SUBJECT: REVIEW OF WCAP-8720, "IMPROVED ANALYTICAL MODELS USED IN
WESTINGHOUSE FUEL ROD DESIGN COMPUTATIONS"

SAFETY EVALUATION BY THE OFFICE OF NUCLEAR REACTOR REGULATION
RELATED TO AMENDMENT NO. 53 TO FACILITY OPERATING LICENSE NO. DPR-39
AND AMENDMENT NO. 50 TO FACILITY OPERATING LICENSE NO. DPR-48

SAFETY EVALUATION
OF THE REQUEST FOR
REMOVAL OF CONSERVATISM
IN THE WESTINGHOUSE PAD COMPUTER CODE

Figure 3.2-9 Hot Channel Factor Normalized
Operating Envelope for Units 1
and 2

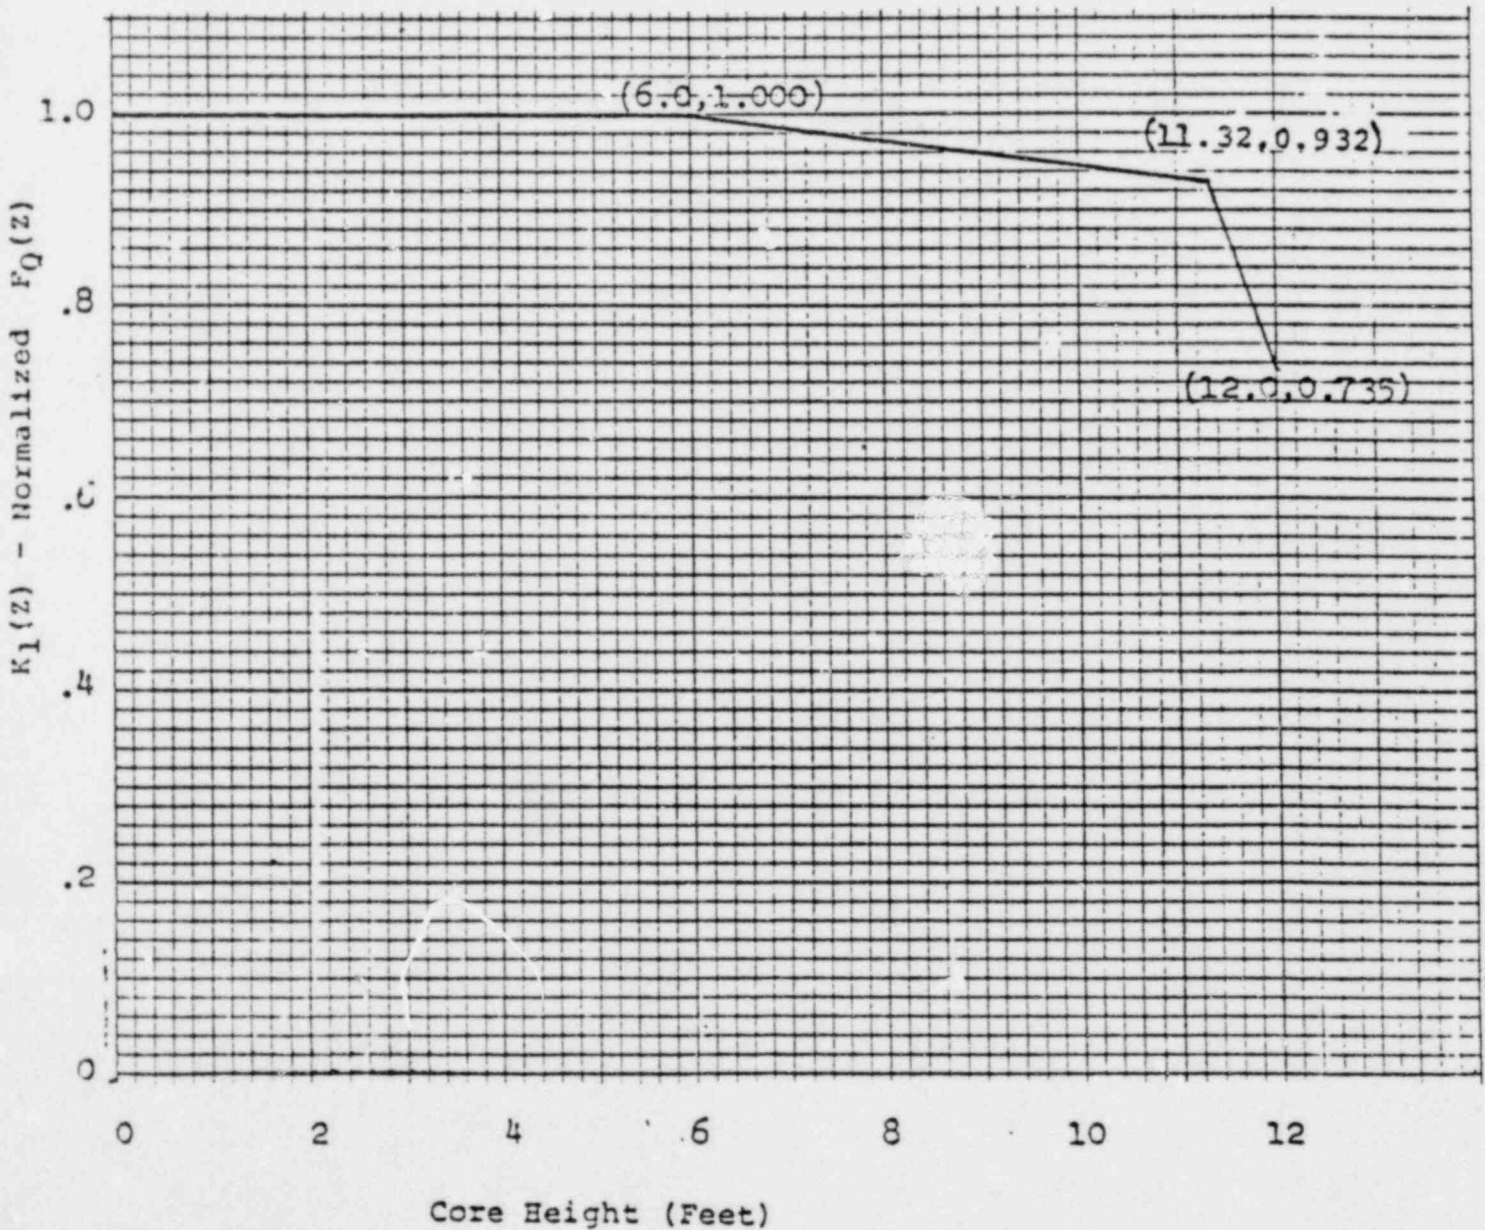
- (a) Change of F_Q to 1.93 for plant operation with 1 percent of steam generator tubes plugged.
- (b) Change of the Hot Channel Factor Normalized Operating Envelope for Units 1 and 2 (Fig. 3.2-9).

F_Q Constant (LOCA Limiting Value) = 1.93

Figure 1

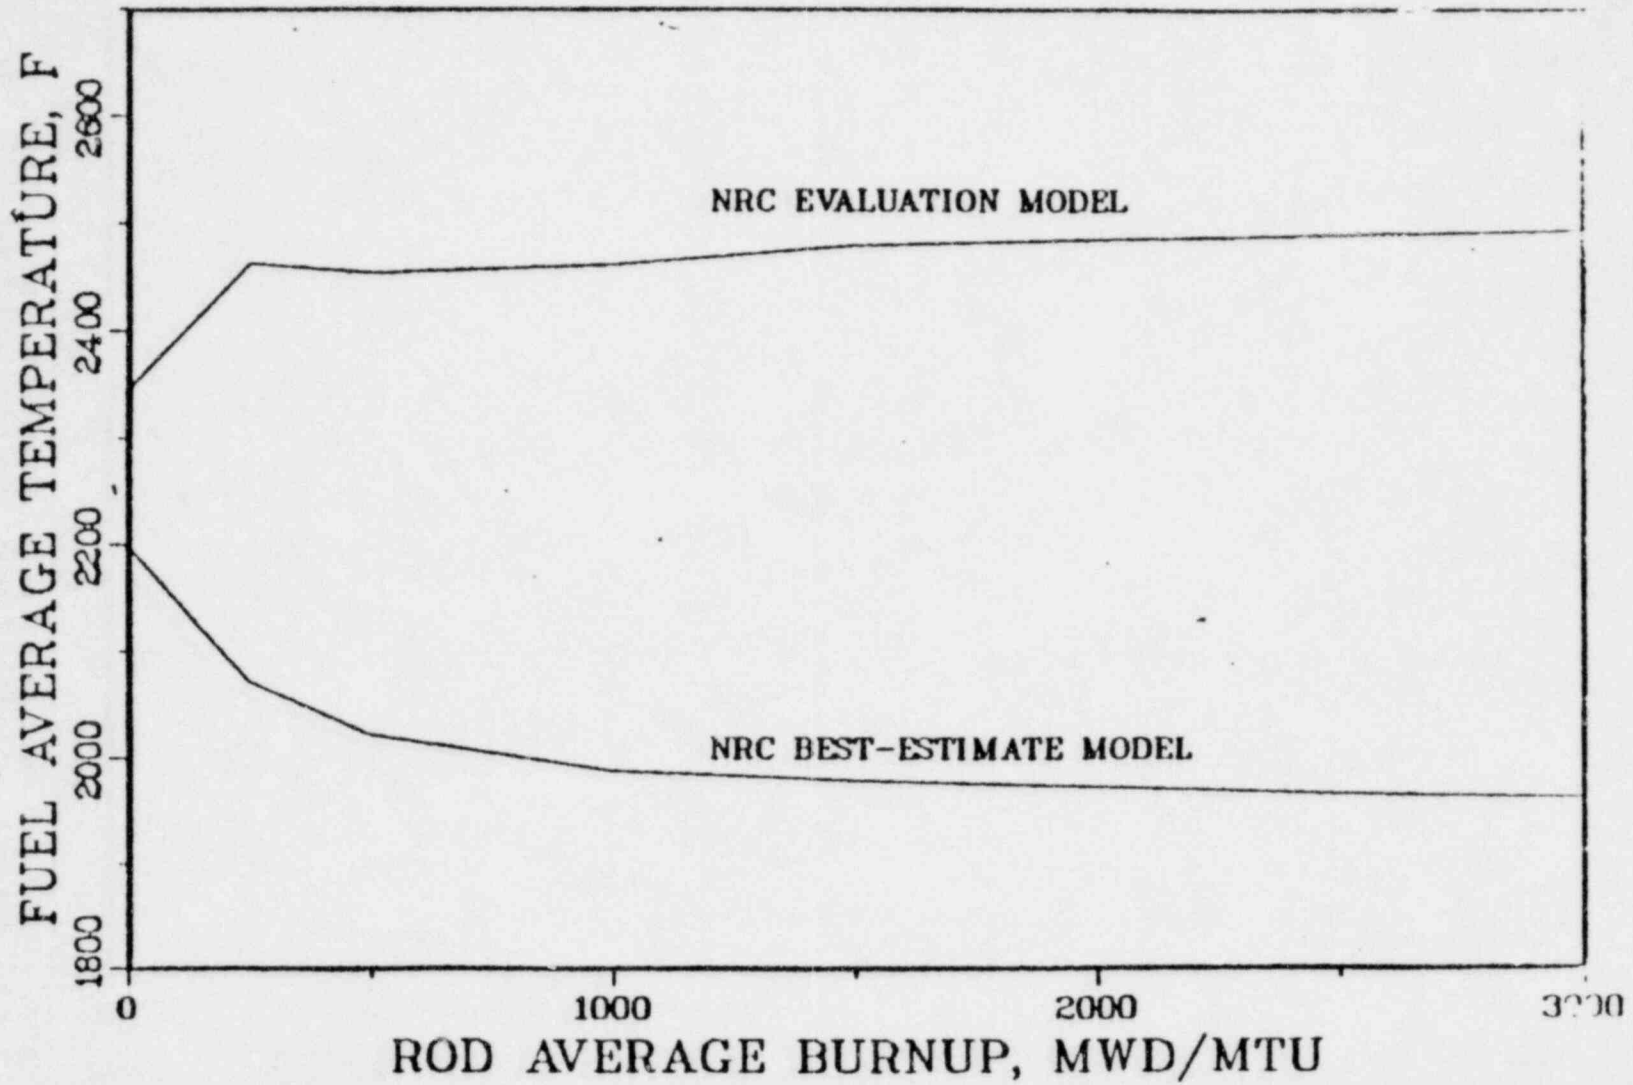
A number of conclusions can be drawn in examining these two figures. First, the current (highest) Westinghouse curve is higher than all of the other curves, including the conservative GAPCON-2 prediction traditionally accepted for audit of LOCA analyses. It is not until much higher burnups are reached that the Westinghouse prediction is exceeded by the conservative version of GAPCON-2. The change at higher exposures is due to the effect of cladding creepdown, which is considered in PAD-3.3, but not in GAPCON-2. The second observation to be made from these figures is that all of the PAD predictions are higher than the best-estimate version of GAPCON-2. This confirms our earlier conclusion that even the "best estimate" version of PAD-3.3 is not best-estimate at all, but conservative. There is additional evidence, not presented here, that even the best-estimate version of GAPCON-2 is conservative with respect to the data.

Figure 2

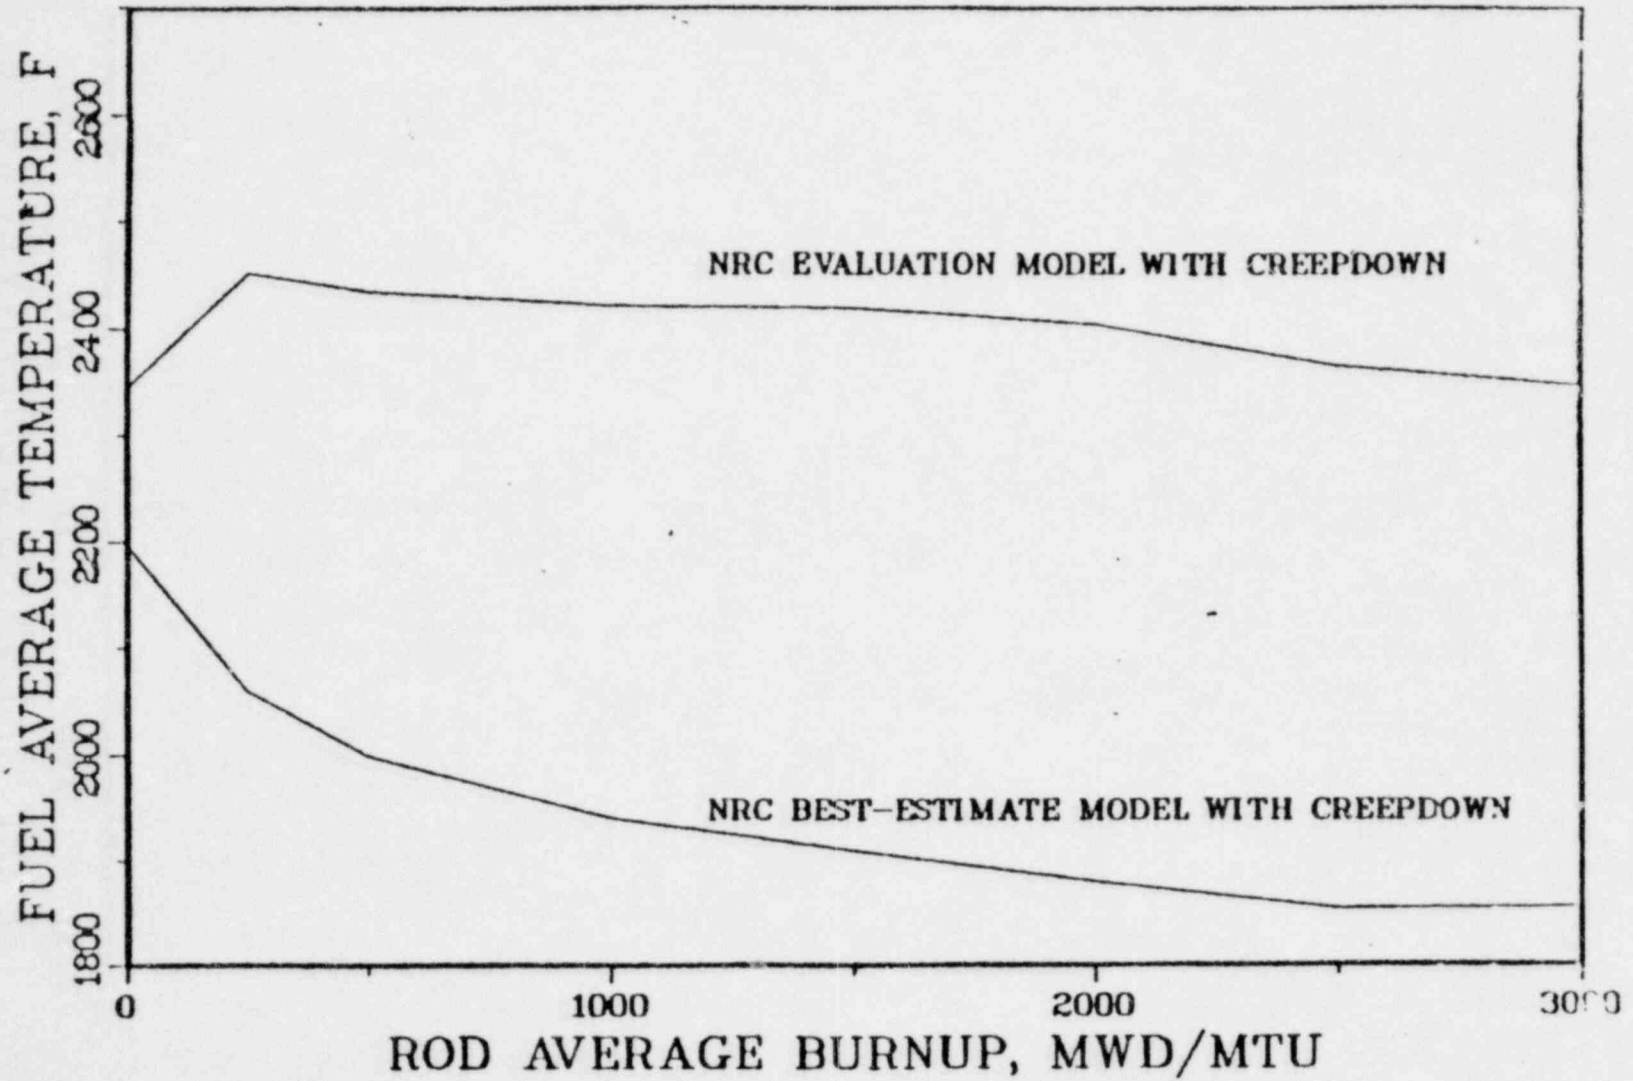
beginning-of-life to a low burnup peak then falling temperatures. It should be noted that the conservative GAPCON-2 and PAD predicted maximums occur at different burnups, but the maximum value calculated by the proposed version of PAD is not unreasonable compared to the conservative version of GAPCON. It may also be noted the best-estimate versions of both GAPCON-2 and PAD-3.3 predict high temperatures at beginning-of-life and monotonically decreasing temperatures thereafter. For the burnup range considered, the best-estimate version of GAPCON was continually and substantially over-predicted by the best-estimate version of PAD.

Figure 3

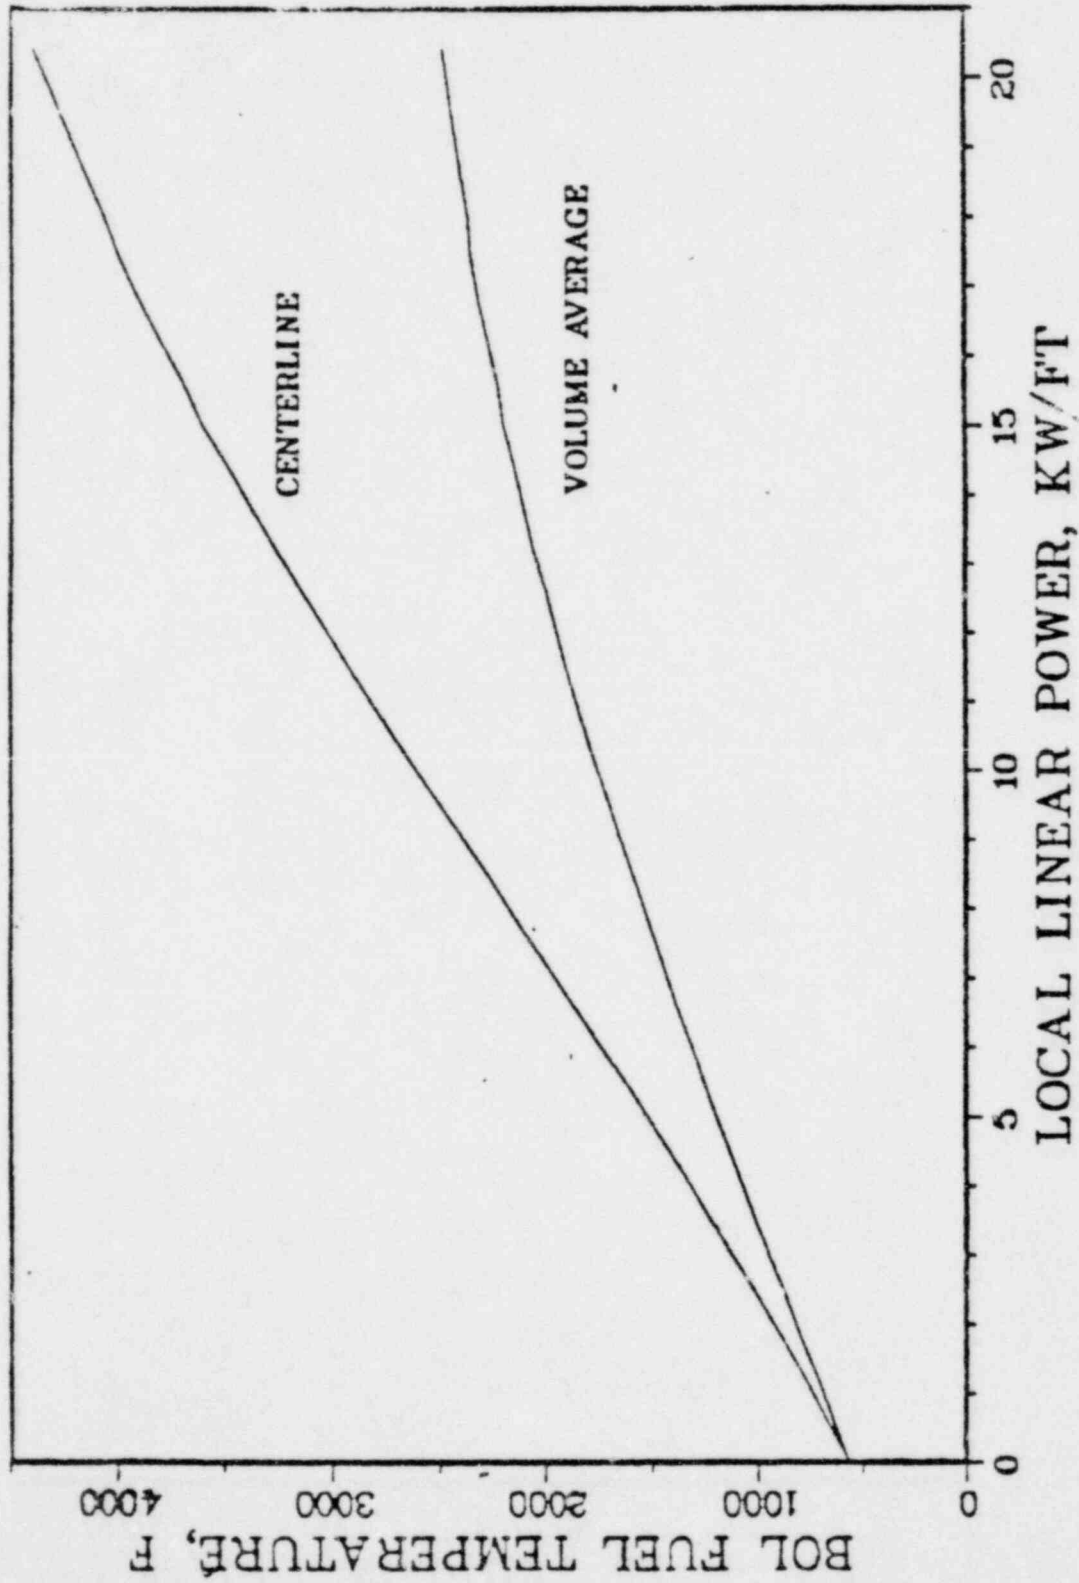
To relate this uncertainty in fuel centerline temperature to volume average fuel temperature, we refer to Figure 3. At a LOCA limit of 15 kW/ft, we find best-estimate fuel volume average and fuel centerline temperature of 2200°F and 3600°F respectively. Adding the margin due to uncertainty in fuel centerline temperature to the best-estimate centerline temperature yields a conservative prediction of centerline temperature. From Figure 4, we find the corresponding best-estimate, conservative and equivalent margin values for volume average temperature. Using this process, we conclude that the PAD-3.3 code meets the proposed criterion based on the experimental data comparison supplied by Westinghouse.

To relate this uncertainty in fuel centerline temperature to volume average fuel temperature, we again refer to Figure 3. Adding 750°F margin to the best estimate centerline temperature

Figure 4

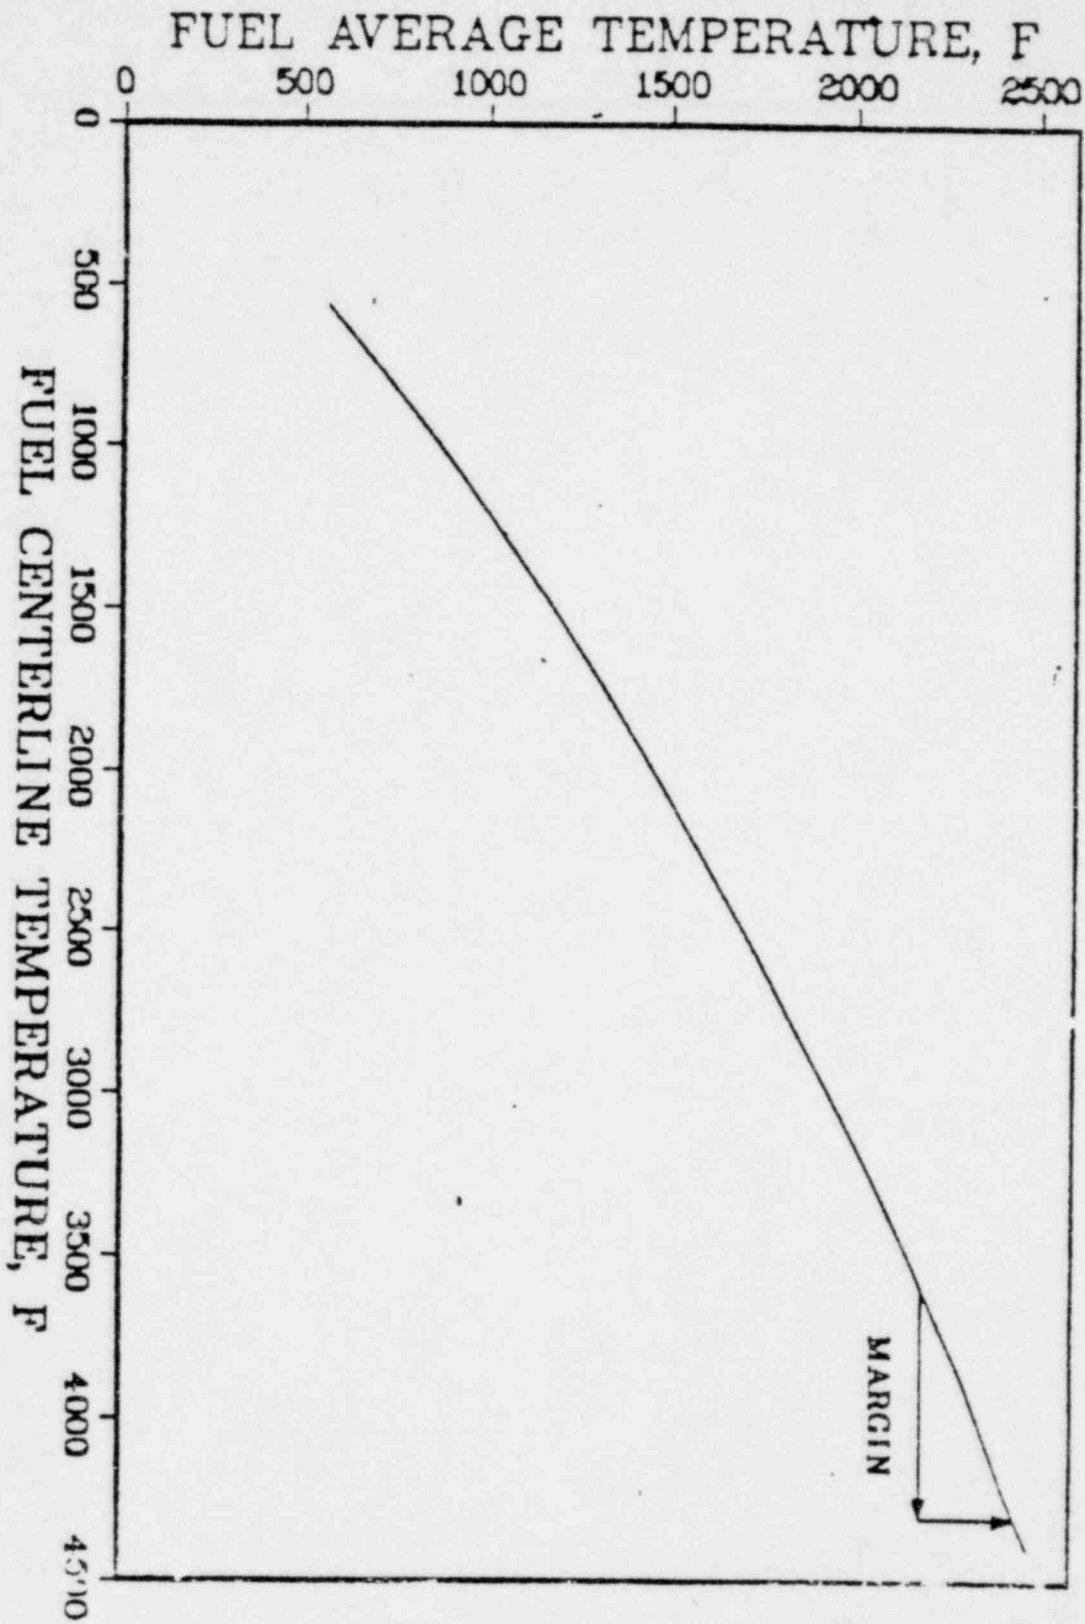
yields a conservative centerline temperature prediction of 4500 F. From Figure 4, we find that this 750°F margin on centerline temperature is approximately equal to a margin of 273°F on volume average fuel temperature. We conclude that FRAP-S3 volume average fuel temperature predictions have a maximum uncertainty of 273°F at a .95/.95 tolerance level. There is evidence (Ref. 30) that these values would drop considerably if the data base were restricted to helium pressurized rods near beginning-of-life with typical densities and gap sizes as proposed by Westinghouse. We have not considered that possibility in this evaluation.
